Limerick Generating Station, Units 1 & 2
Facility Operating License Nos. NPF-39 and NPF-85
NRC Docket Nos. 50-352 and 50-353

Subject: Request for License Amendments Related to Application of Alternative Source Term

Figure 1: Layout of Release Points for LGS

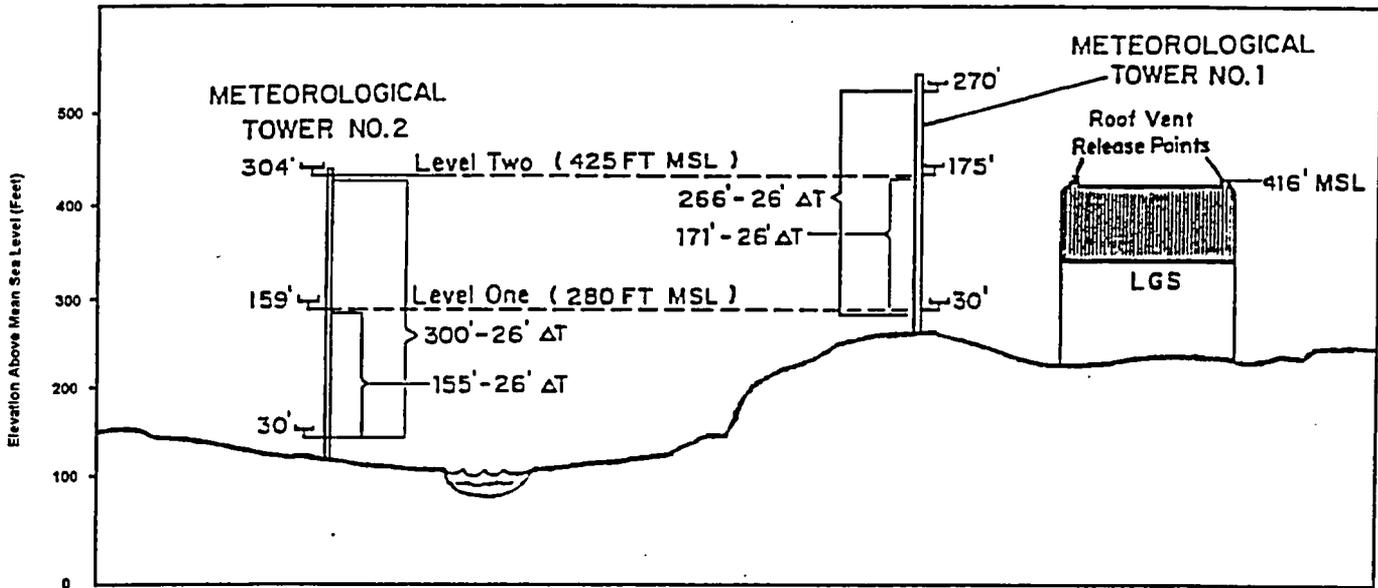
Figure 1 shows the "Layout of Release Points for LGS."

Figure 1 illustrates the release and intake points for LGS. The χ/Q values for these release-intake combinations are summarized in Tables 13 and 14a.

RECENTLY IRRADIATED FUEL

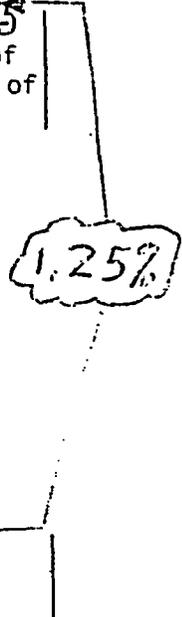
~~*Required when (1) irradiated fuel is being handled in the refueling area, secondary containment, or (2) during CORE ALTERATIONS, or (3) during operations with a potential for draining the reactor vessel with the vessel head removed and fuel in the vessel.~~

INSERT 4

Figure 2

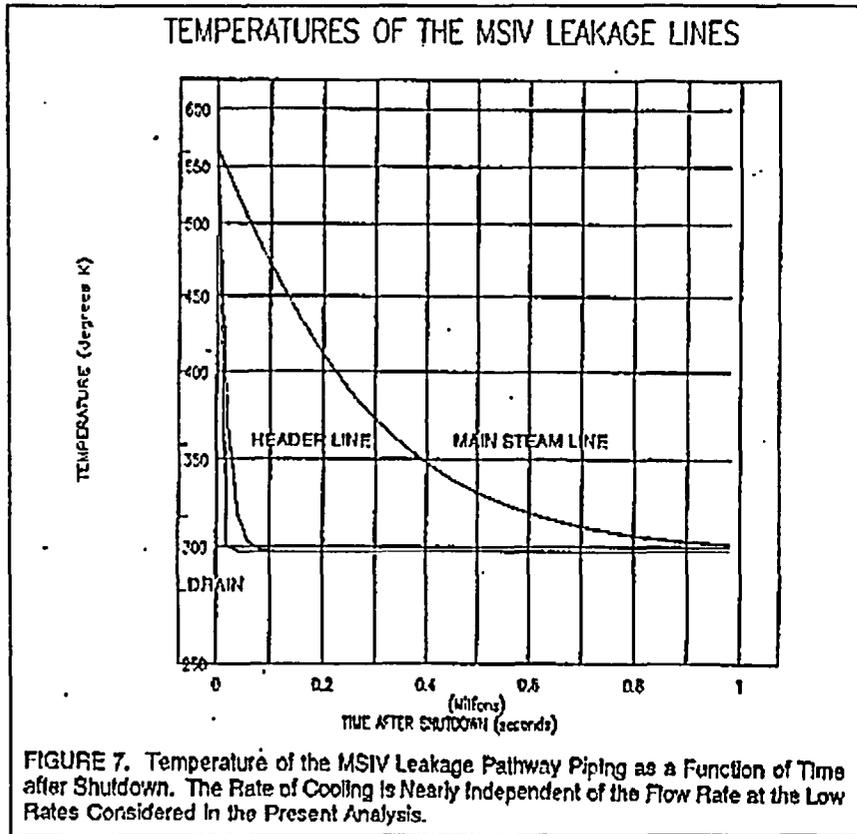
Figures	Page
Figure 1, Control Room Isodose Diagram	8
Figure 2, Assessment of Steam Line Temperatures for Piping Deposition Credit Analysis	11
